WINTER GREEN

2D2

SUITE: 335 BUILDING B

CONSTRUCTION SUMMARY

KITCHEN PLAN 2D2

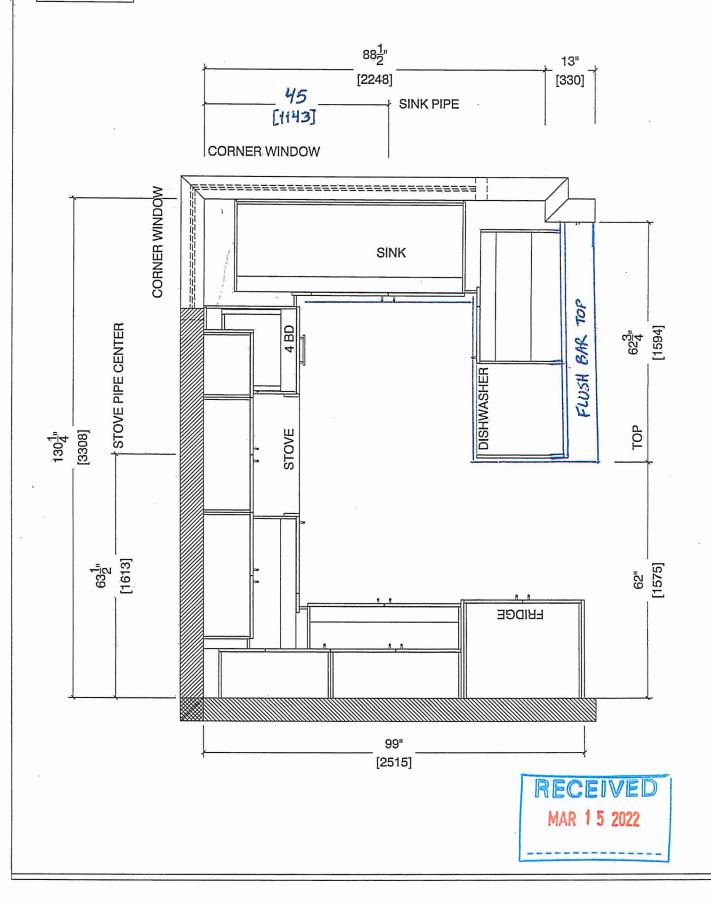
1 - KITCHEN & BATHROOMS - Purchaser has DECLINED All Upgrades offered during decor appointment at the decor centre for kitchen & bathroom cabinetry. Standard Kitchen Layout & Standard Bathroom Vanities to be installed as per standard plan. (See Sketch) Note:

SINK WALL ELEVATION 2D2

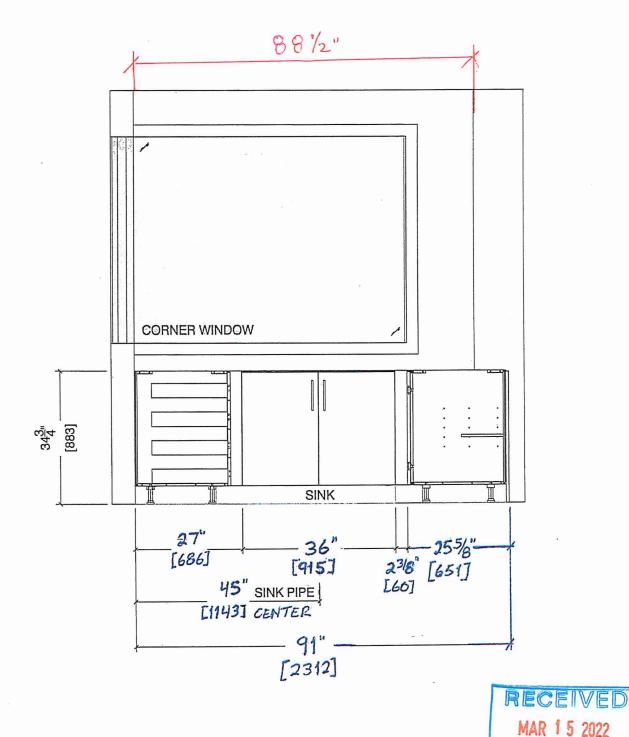
1 - KITCHEN-PLUMBING - Install the builders standard Top mount sink in the kitchen- Install the BLANCO HORIZON 2.0 (7") Top mount Sink-Model # 401124 (see sketch)
